REPLACING PAGE ADDENDUM

**EQUALIZATION OF
15KC LOCAL PROGRAM CIRCUITS**

1.001 This addendum supplements Section 320-145-504 Issue 3. The attached pages must be inserted in the section in accordance with the filing instructions above.

1.002 This addendum is issued to revise information on voice and crosstalk tests.

Fig. 3 - Final Noise Test for 15 kc Circuit

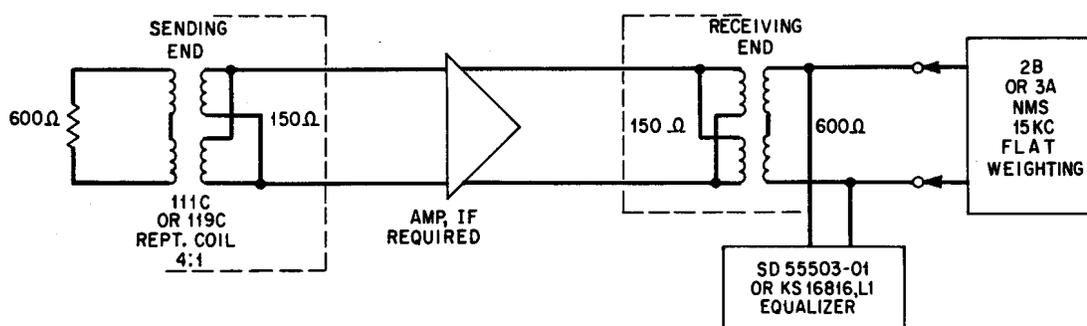
Paragraph 3.03 changes the db dial setting of the NMS to provide a meter reading at or above "0" when measuring circuit noise at the "receiving end" of the circuit.

3.03 The circuit noise at the "receiving end" of the circuit should not exceed 33 dbrn when referred to the +8 vu level point. The DB dial of the NMS should be set to bring the meter indications above the "0" mark. Occasional extreme meter excursions may be ignored. The noise should be measured during the heavy traffic period.
